WORKSHOP AGENDA

Planning Commission

January 14, 2025 @ 5:30 PM

For the January 28, 2025 Regular Meeting @ 6:00 PM

USER: JMB010
FILE: 36257/36257/0404_CAD/CIVIL/LOT/36257/04_C2.01.dwg
SAVED: 11/25/2024
PLOTTED: 11/26/2024

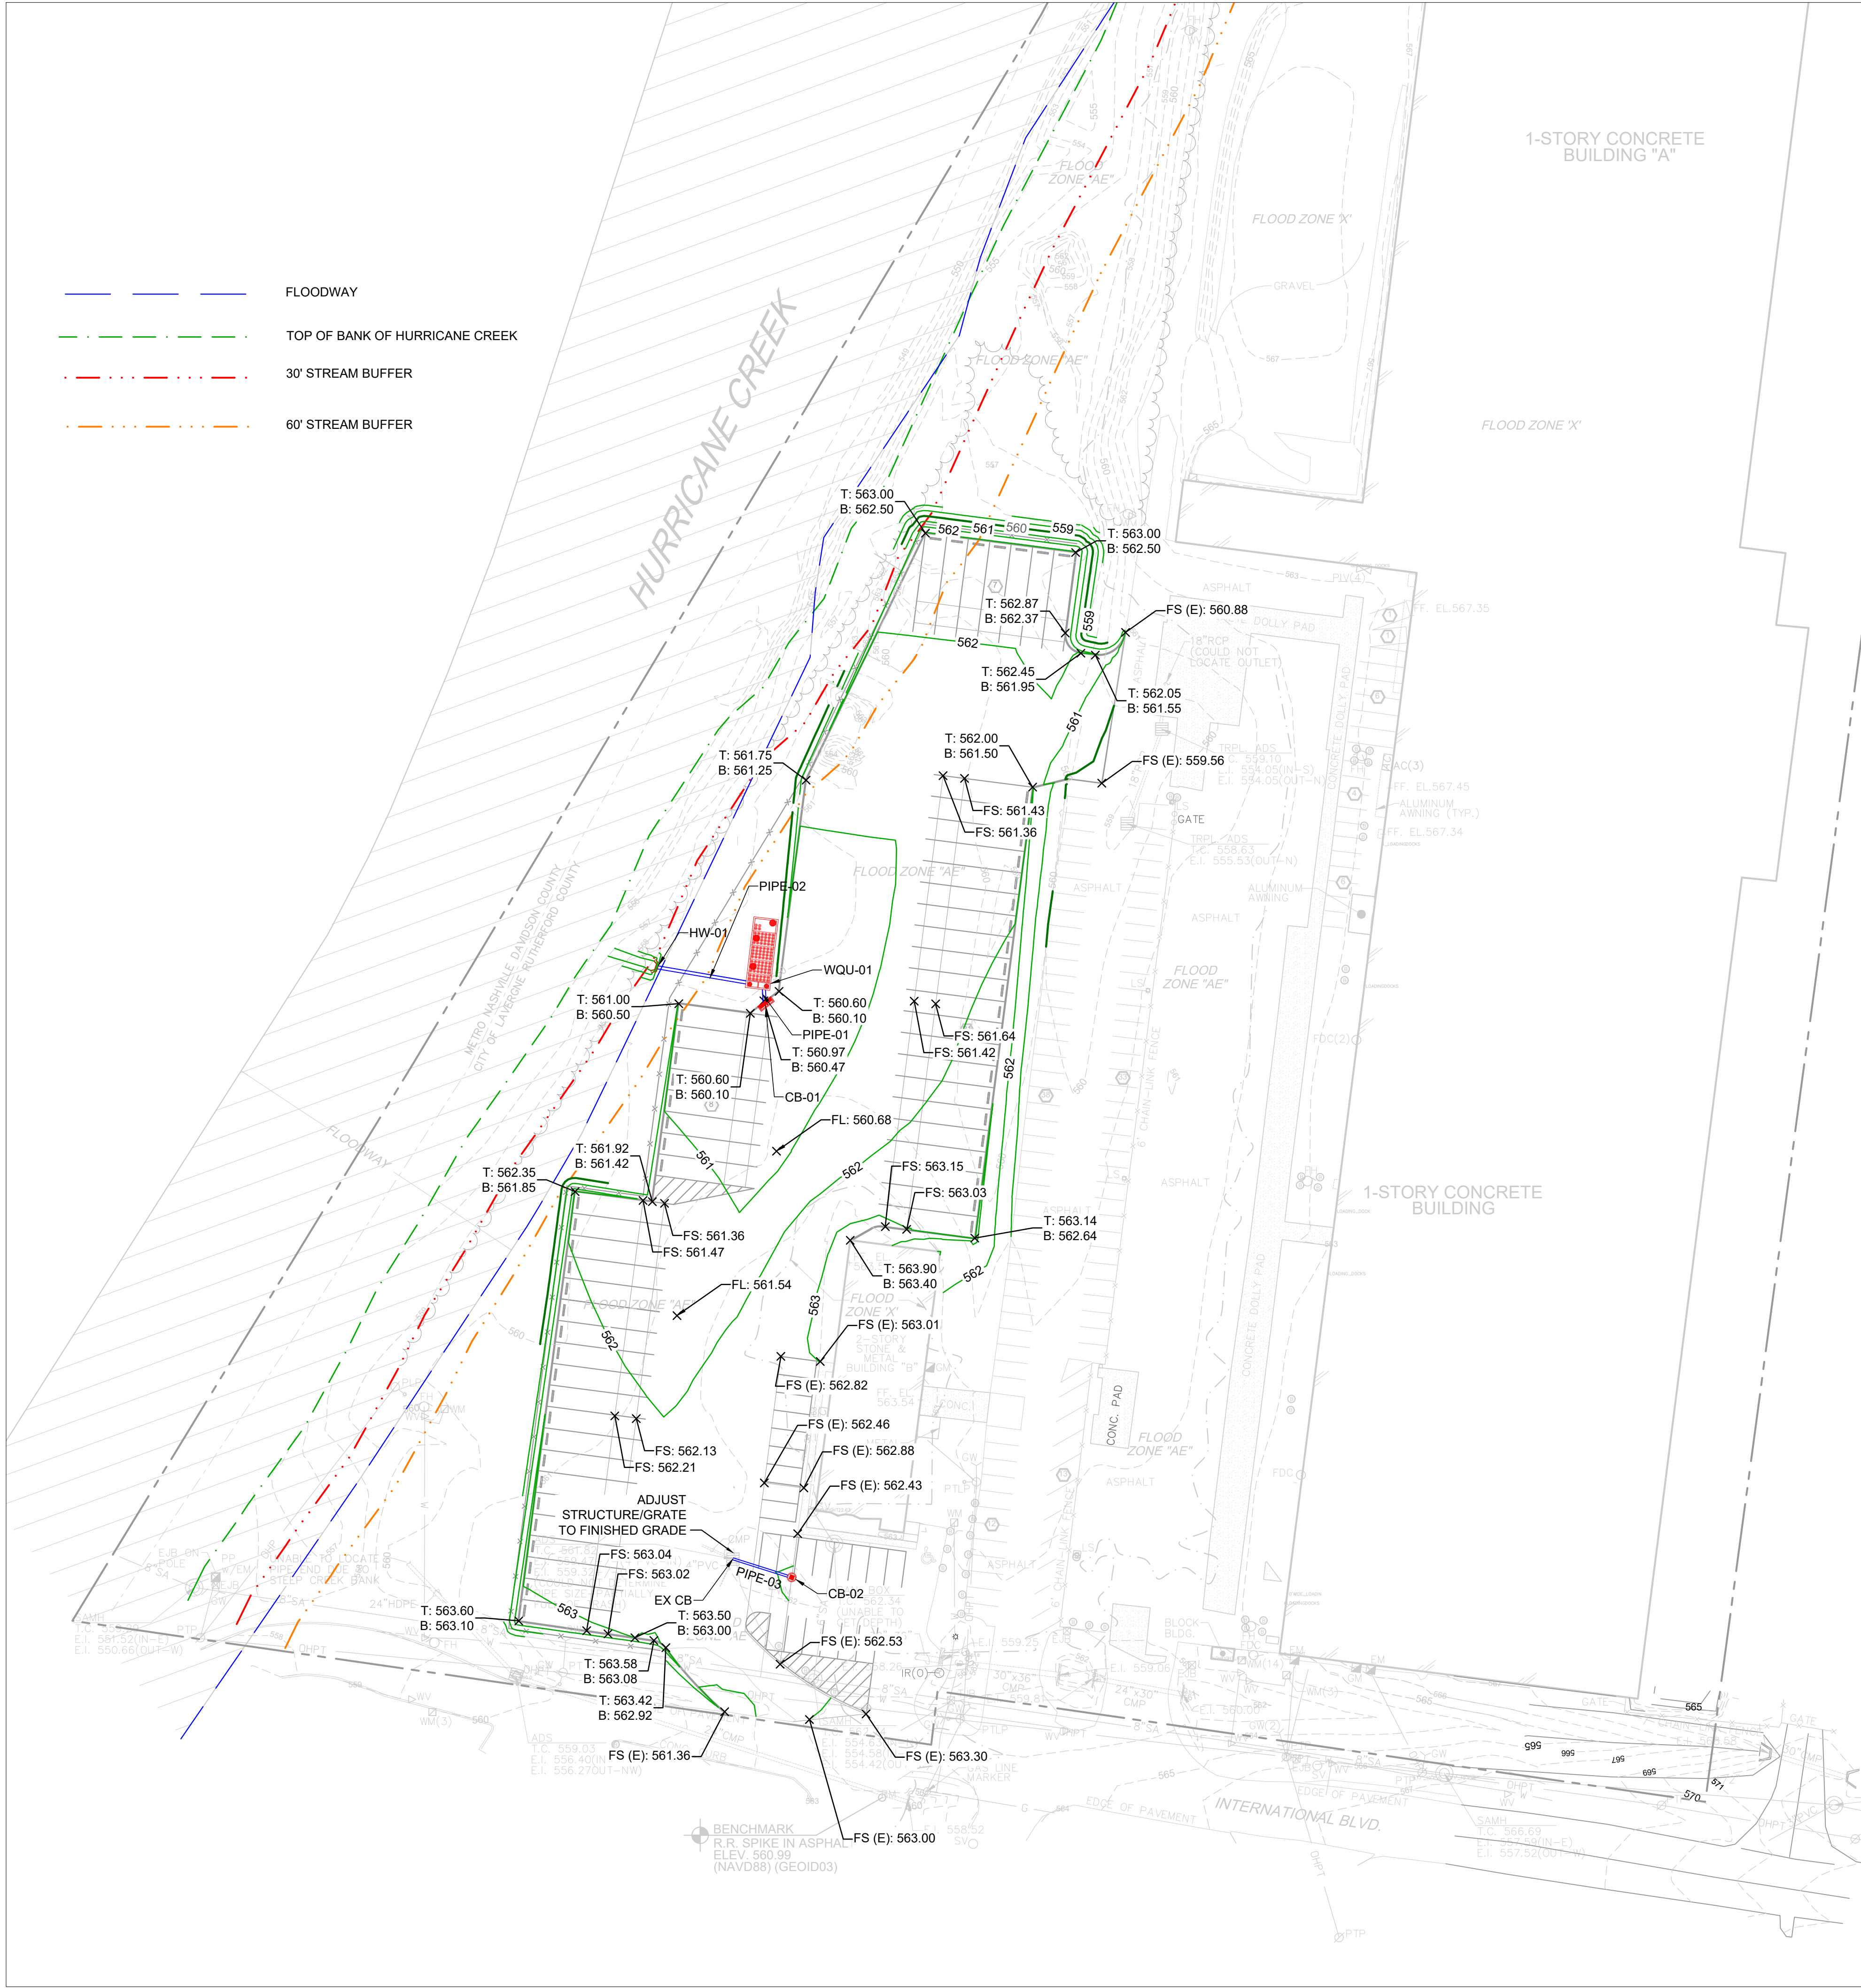
7. On sheet C2.01, call out existing water and sanitary sewer services to remain with a note that states that contractor must keep these lines protected and in service.

A1-1

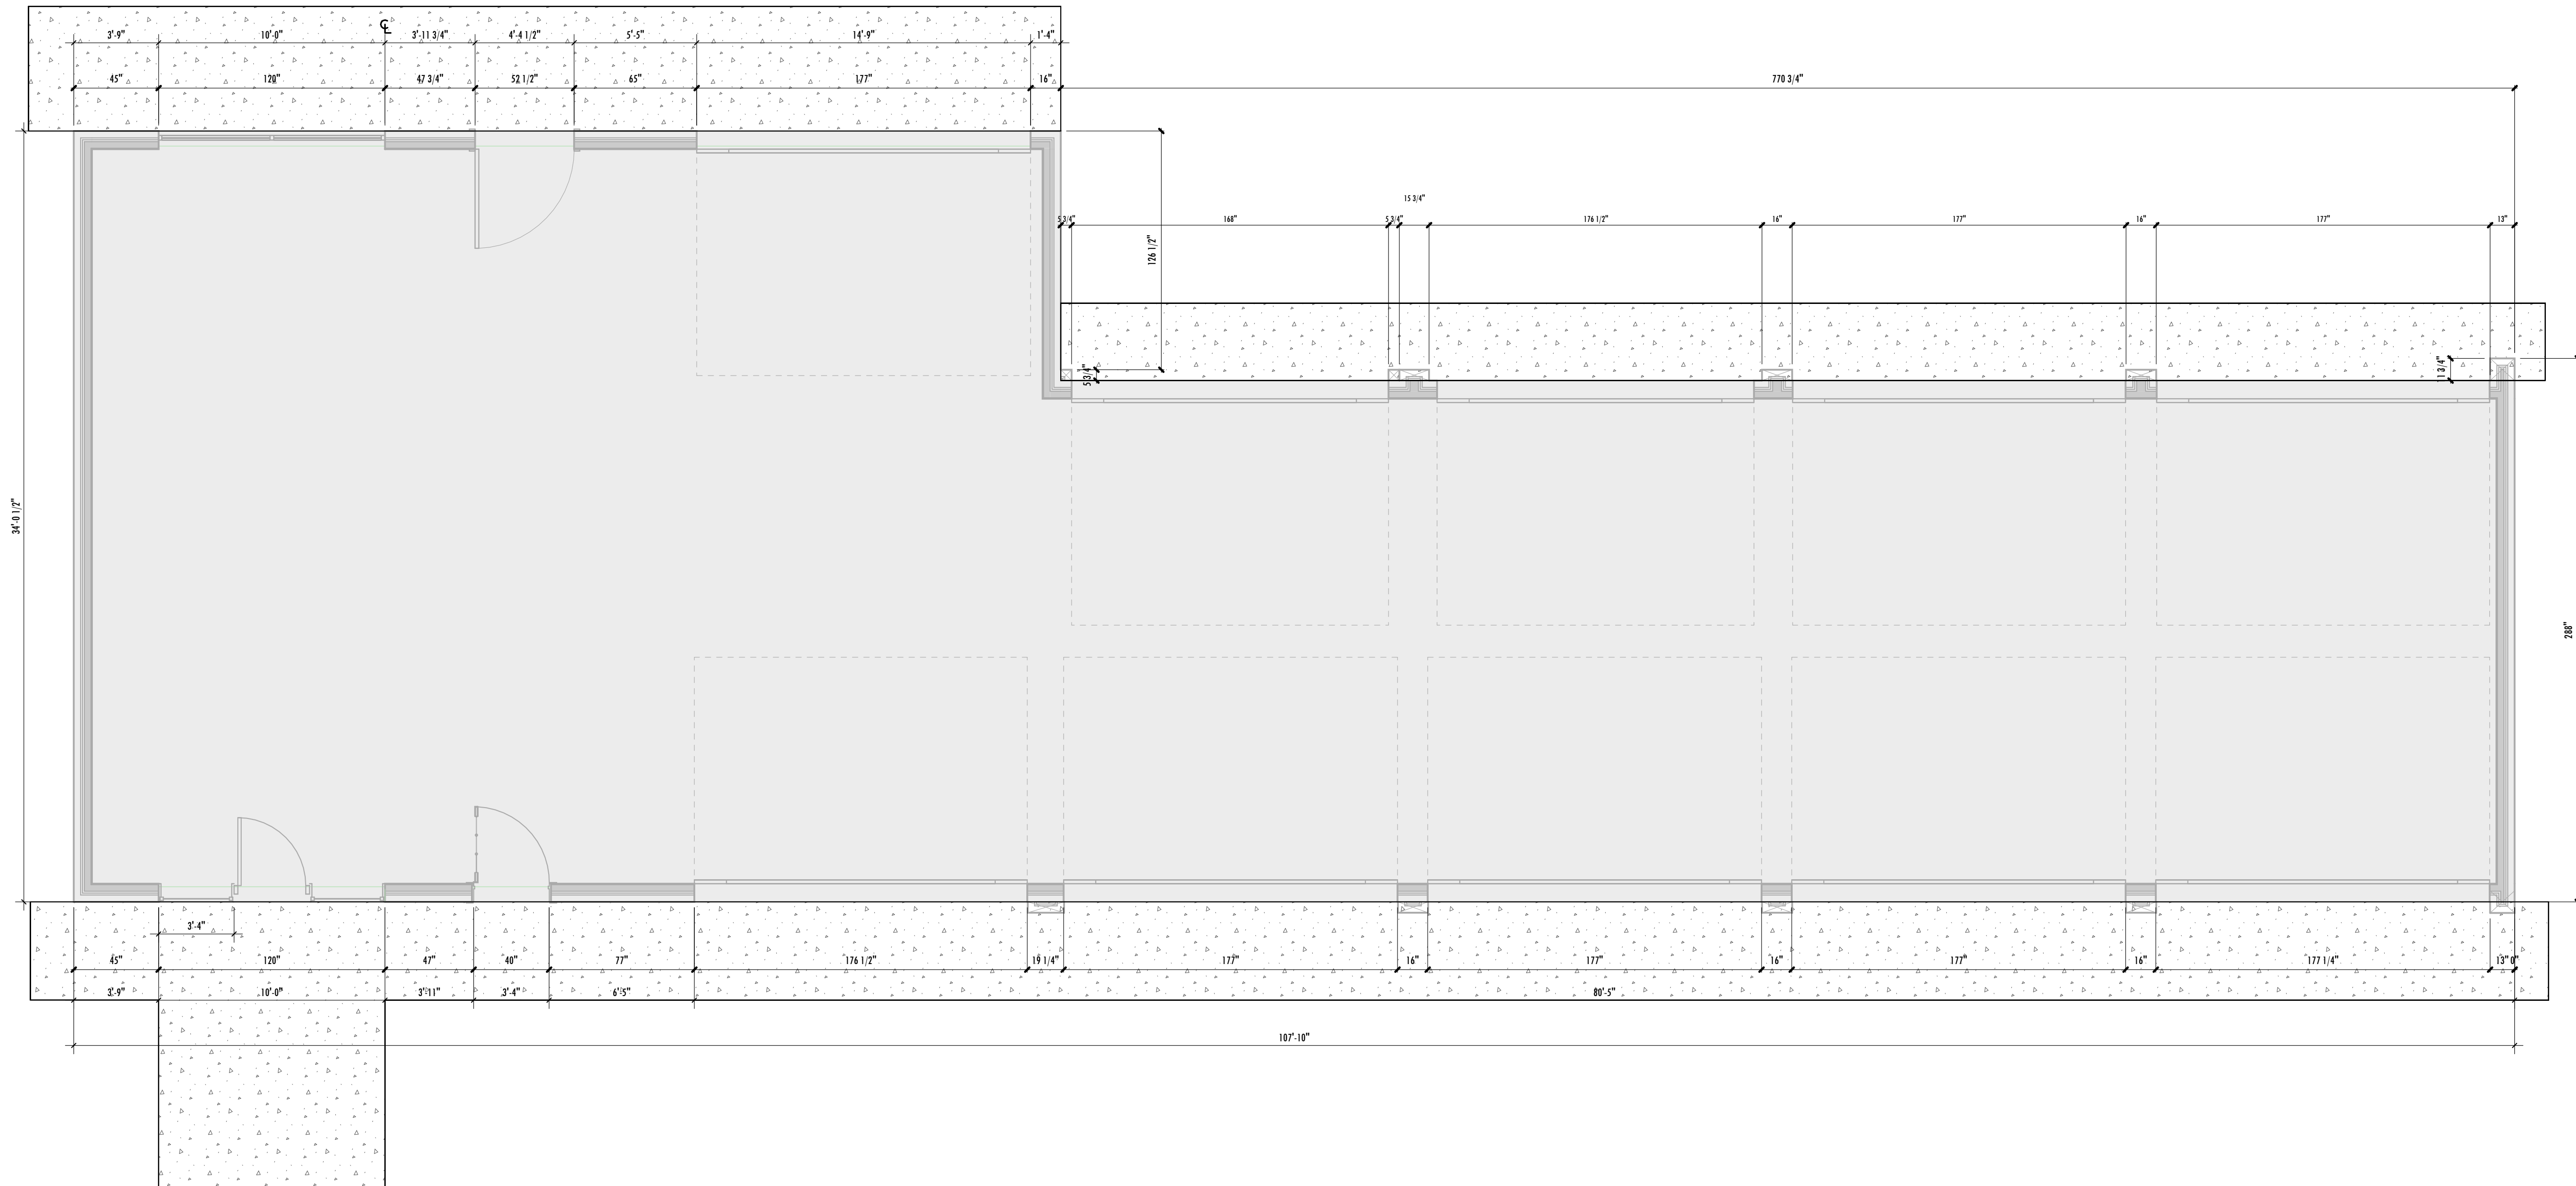
1. Mechanic Shops are not Allowed in C-2;
2. Sheets A-1 and other sheets say "Mechanic";
3. Site Plan shall not be named 5130 Murf Rd - There is no such address;
4. The only address that shall be used is 5136 Murf Rd;
5. Color Elevations are required;
6. A Landscape Plan is required;
7. Fee in Lieu of a sidewalk is required;
